Carrigaline Cycle/Pedestrian
Track - Phase 1
(Section B)

Stage 1 Road Safety Audit

Document Ref:	P23056-PMCE-XX-XX-RP-SA-RSA-3_ZZ_02
----------------------	--

Location: Drawing no. 281905-UM-SB-ML-DR-CH-00012

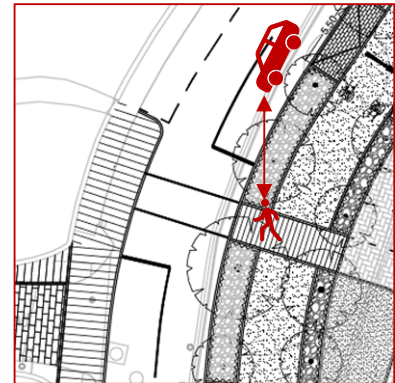
Summary: Unclear what type of pedestrian crossing is proposed, and insufficient forward visibility towards the crossing for approaching drivers.

It is unclear what type of crossing (e.g. Zebra, Pelican, Toucan, etc.) is proposed on Strand Road north of its junction with Glen Road. Forward visibility towards signals or Belisha beacons may be restricted by the horizontal alignment to the north of the crossing and by the row of trees at the edge of the footpath.

Should a driver's visibility to a pedestrian (or cyclist) waiting at the crossing be restricted there is a risk of drivers overshooting the stop line and colliding with vulnerable road users.

Ensure sufficient inter-visibility is provided between drivers & pedestrians waiting to cross. Additionally, undertake an assessment of the demands in this area to determine the most appropriate form of crossing.

Location: Drawing no. 281905-UM-SB-ML-DR-CH-00012

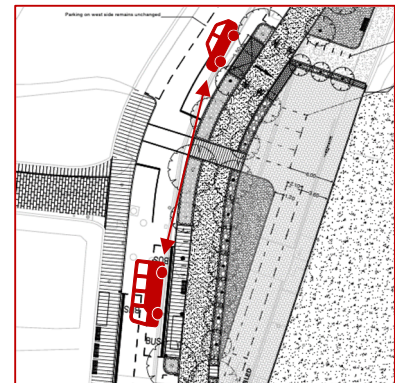
Summary: Bus stop provided directly after horizontal curve.

The southbound bus stop on Strand Road has been indicated directly after a horizontal curve. A stationary bus may not be seen by southbound drivers travelling around the bend due to the restrictions to visibility splayed posed by the horizontal alignment, the trees and roadside furniture, leading to rear-end-shunt collisions.

Review visibility at this location, and if required, the bus stop should be relocated.

Location: Drawing no. 281905-UM-SB-ML-DR-CH-00012

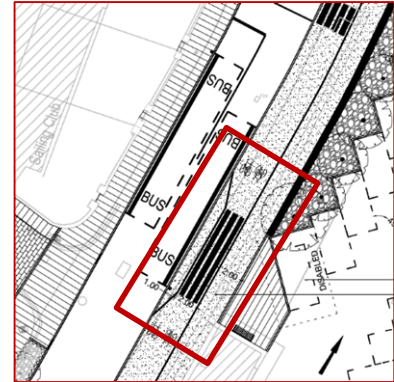
Summary: Parking provision may restrict pedestrian movement into and out of the carpark, and limit inter-visibility.

Once fully occupied, the parking provision within the carpark near the controlled pedestrian crossing may restrict pedestrian movement and inter-visibility between pedestrians and other users of the carpark. This may result in vehicle/pedestrian collisions.

A greater offset between the likely pedestrian desire line and the adjacent parking provision should be provided, noting that there may be groups of pedestrians entering the carpark.

Location: Drawing no. 281905-UM-SB-ML-DR-CH-00013

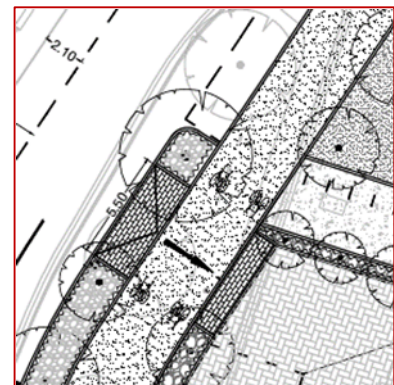
Summary: Bus Stop layout may increase the risk of pedestrian/cyclist collisions.

The proposed works include shared use facilities for pedestrians and cyclists, however in the location of the southbound bus stop, the cyclist and pedestrian facilities are locally segregated. The segregated facilities demand several elements to operate such as tactile paving arrangements, and traffic signs as the facility transitions between the different cross sections. As these demands occur within a limited section of the scheme, the RSA Team is concerned that the segregated facilities will lead to confusion and the introduction of conflict points between road users.

Furthermore, the cycle track is narrowed at the proposed bus stop, with cyclists required to continue through a narrow channel where pedestrians will be waiting for the bus, or bus passengers will be disembarking. This will bring cyclists and pedestrians into direct conflict, and may lead to pedestrian/cyclist collisions, particularly where visually impaired pedestrians are using the bus stop. This problem will likely be exacerbated by the growth of battery powered bicycles and scooters, where users can travel at, and maintain, high speeds on the cycle track.

The layout should be simplified to remove the need for complex cross sectional transitions and conflict zones presented in the current design.

Location: Drawing no. 281905-UM-SB-ML-DR-CH-00012 & Drawing no. 281905-UM-SB-ML-DR-CH-00013

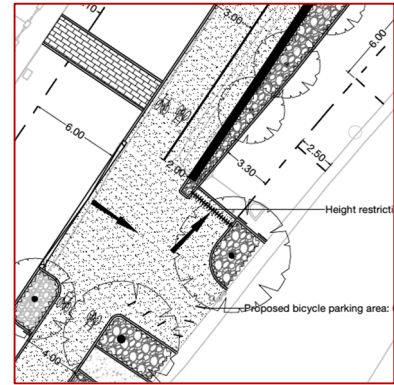
Summary: Swept path analysis within the carparks has not been provided to the Audit Team and it is therefore unclear if all vehicles can safely complete turning manoeuvres within the extents of their traffic lane.

Information regarding the swept path analysis of vehicles entering/exiting the two carparks has not been provided to the Audit Team. It is unclear if the revised road layout at the carpark accesses will accommodate the swept path of all vehicles, particularly cars towing boats, entering and exiting the carpark areas.

If vehicles cannot complete turning manoeuvres within the carriageway extents there is a risk of kerb strikes, collisions with other road users or collisions with items of roadside furniture.

Ensure the swept path of all vehicles can safely enter/exit the carparks.

Location: Drawing no. 281905-UM-SB-ML-DR-CH-00012 & Drawing no. 281905-UM-SB-ML-DR-CH-00013

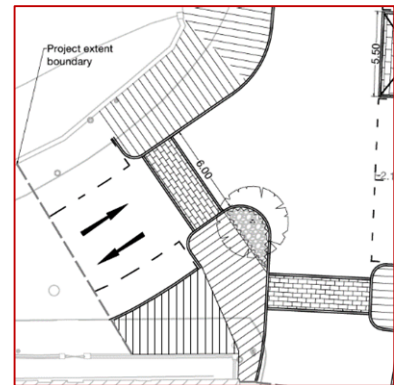
Summary: No junction control or priority type has been indicated at junctions within the scheme extents.

The junction control (stop, yield etc.) at the junctions and carpark accesses within the proposed scheme has not been indicated. It is therefore unclear who has priority at these junctions.

This could result in driver confusion and hesitation leading to collisions should drivers assume that they have priority over vehicles in adjacent roads leading to low speed collisions and material damage.

Ensure the junction control at all junctions is clear and that drivers are sufficiently advised of the priority.

Location: Drawing no. 281905-UM-SB-ML-DR-CH-00012 & Drawing no. 281905-UM-SB-ML-DR-CH-00013

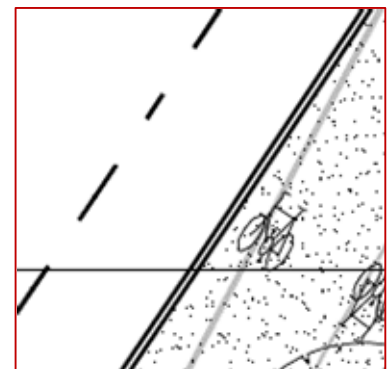
Summary: The proximity of the proposed parallel parking and the adjacent cyclists/pedestrian facilities may result in vehicle doors opening into the cyclists/pedestrian facilities presenting an obstacle for cyclists.

Parallel parking is proposed directly adjacent the cyclist/pedestrian facilities on the eastern side of Strand Road with a kerb indicated between the parking and the pedestrian/cyclist facilities. The proximity of the parking bays to the pedestrian/cyclist facilities may result in a vehicle door opening into the cyclist/pedestrian facilities and presenting an obstacle to cyclists resulting in personal injury collisions.

A buffer zone should be provided between the cyclist/pedestrian facilities and the parking bays.

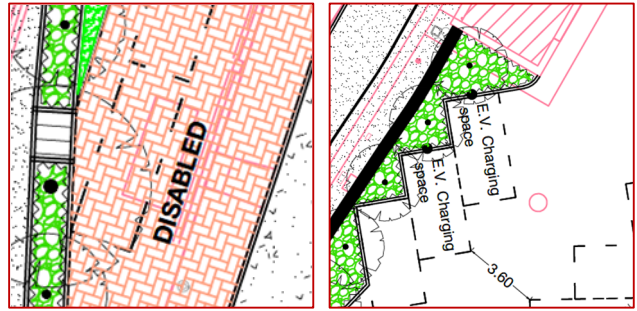
- 4.1 Most of the proposed parking spaces within the carpark appear to have similar dimensions, which do not appear to make allowance for EV parking space requirements. There is a risk, therefore, that carparking spaces intended to accommodate mobility impaired and EV parking will be insufficient sized.

Sufficient space should be provided at the proposed mobility impaired and EV parking spaces in accordance with the Traffic Signs Manual.
